Access Compliance Report

Public Rights-of-Way

Intersection ID: 5704	Main Street: W_W_T_HARRIS_BV	Cross Street: N_TRYON_ST	Location: N
ADA ID: 605BB1CE8EC6	Ramp Type: Perp	Initial Pass/Fail: Fail	Overall Compliance: No
			Severity Score: 13.75

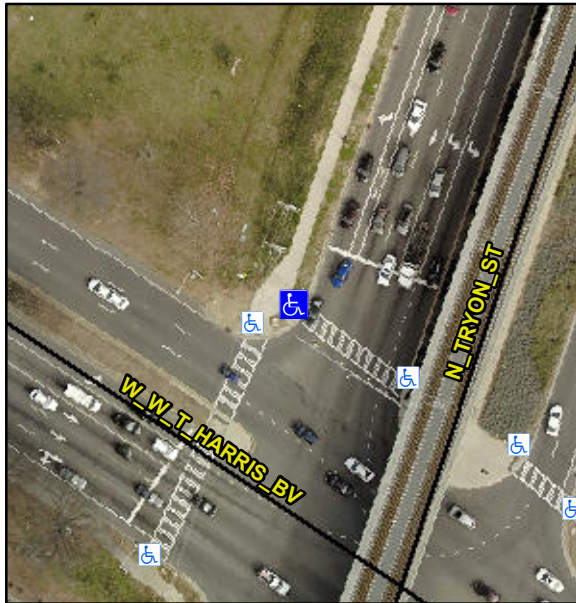
Not Found, R304.2.2

Compliance	Description	Data	Compliance	Description	Data
N/A	Ramp Length (in)	97.0	No	Ramp Slope (%)	10.2
Yes	Ramp Width (in)	48.0	Yes	Ramp XSlope (%)	2.6
N/A	Flare Type LT	N/A	N/A	Flare Type RT	N/A
N/A	Flare Slope LT (%)	N/A	N/A	Flare Slope RT (%)	N/A
N/A	Flare Traversable LT?	N/A	N/A	Flare Traversable RT?	N/A
N/A	Landing Length (in)	N/A	N/A	DWS Provided?	N/A
N/A	Landing Width (in)	N/A	N/A	DWS Contrast?	N/A
N/A	Landing Slope (%)	N/A	N/A	DWS Length (in)	N/A
N/A	Landing X Slope (%)	N/A	N/A	DWS Full Width?	N/A
N/A	Landing Curb? (Y/N)	N/A	N/A	DWS Offset (in)	N/A
N/A	Shared Landing?	N/A			
N/A	Gutter Ponding?	N/A	N/A	Gutter Slope (%)	N/A
N/A	Gutter Lip Ht (in)	3.5	N/A	Gutter X Slope (%)	N/A
N/A	Painted X Walk1?	No	N/A	Painted X Walk2?	N/A
	X Walk 1 Direction	To SE		X Walk 2 Direction	N/A
N/A	X Walk 1 Width (in)	N/A	N/A	X Walk 2 Width (in)	N/A
	X Walk 1 Slope (%)	4.7		X Walk 2 Slope (%)	N/A
	X Walk 1 X Slope (%)	3.8		X Walk 2 X Slope (%)	N/A

Remove & Replace Entire Ramp.
